October 30, 2025

PROJECT NAME: FLORIDA HORSE PARK RV SITE
PROJECT NUMBER: 2025040020
APPLICATION: MAJOR SITE PLAN #32700

FLORIDA HORSE PARK RV SITES
MAJOR SITE PLAN
MARION COUNTY, FLORIDA
FUTURE WATER MAIN
EXTENSION SKETCH

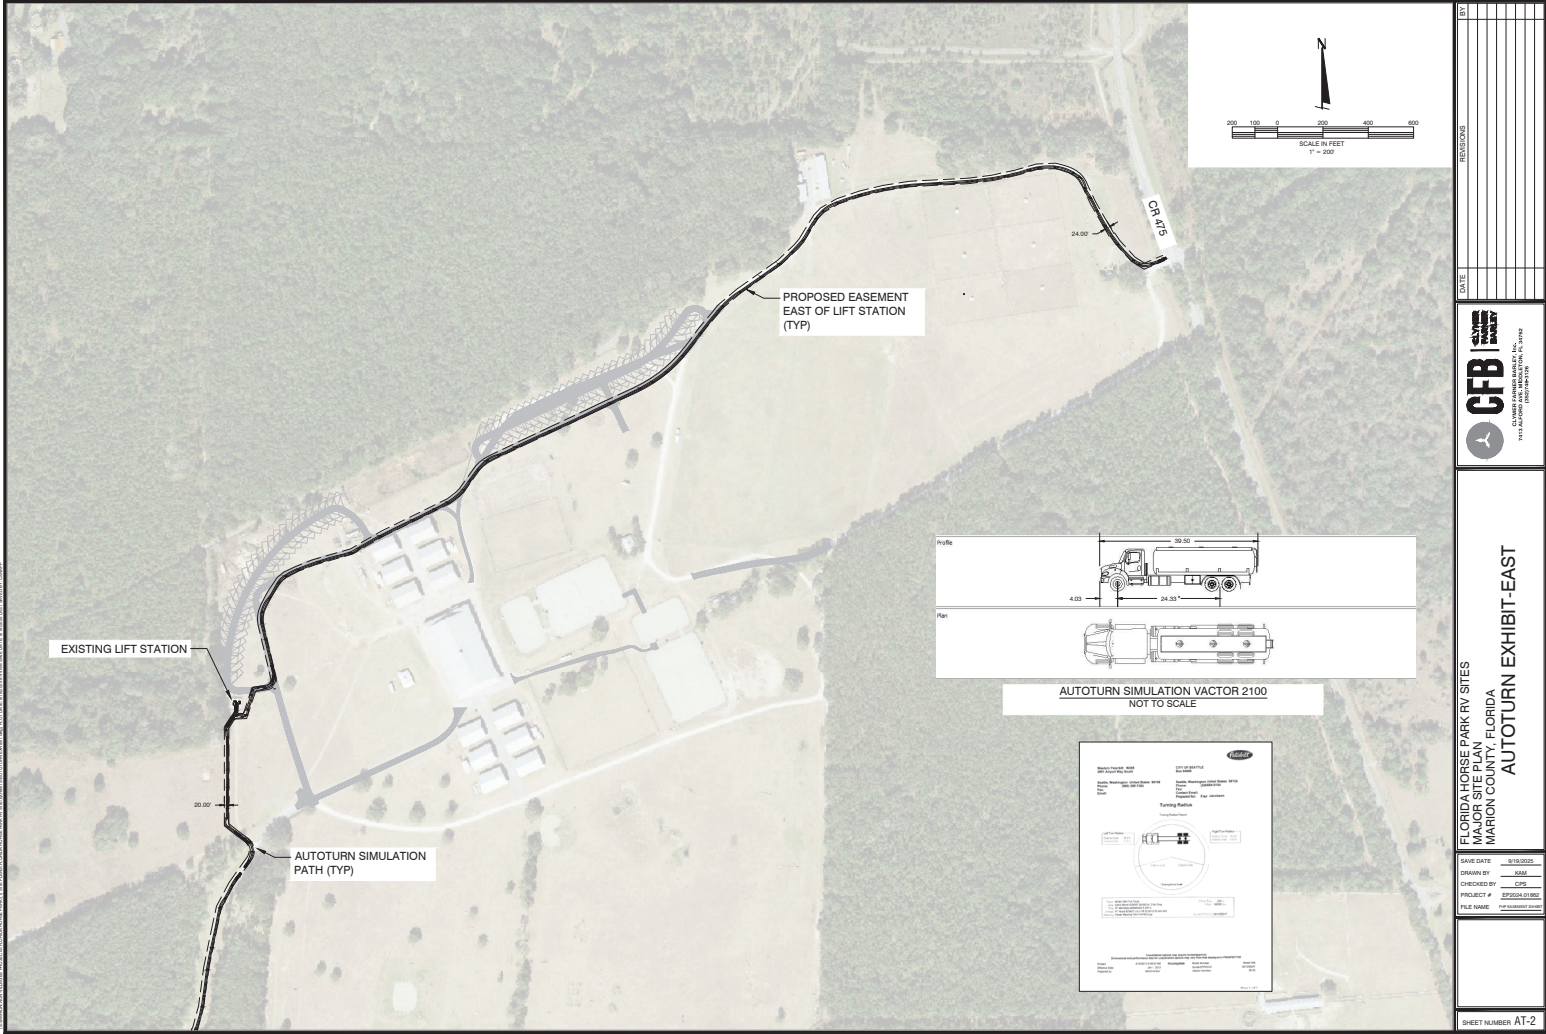
REMARKS: 10/3/25 – Parcel is required to extend and connect to the Marion County Utilities water main

by installing a master meter on the southwest corner of the property to serve Parcels 37343-000-00 and 37343-001-00. The EOR must show a sketch of the future extension and connections on the plans and label them accordingly, with a note stating that the extension and connection will be submitted under a separate cover.

REMARKS: 10/3/25 – See previous comment. The water main extension and connection must be referenced on this plan set as a future site improvement. 7/24/25 No discussions have been had since 5/2025. See previous comment. MCU water may be within connection distance.

NOTE: FUTURE WATER MAIN EXTENSION AND CONNECTION
PLANS TO BE PERMITTED UNDER SEPARATE COVER
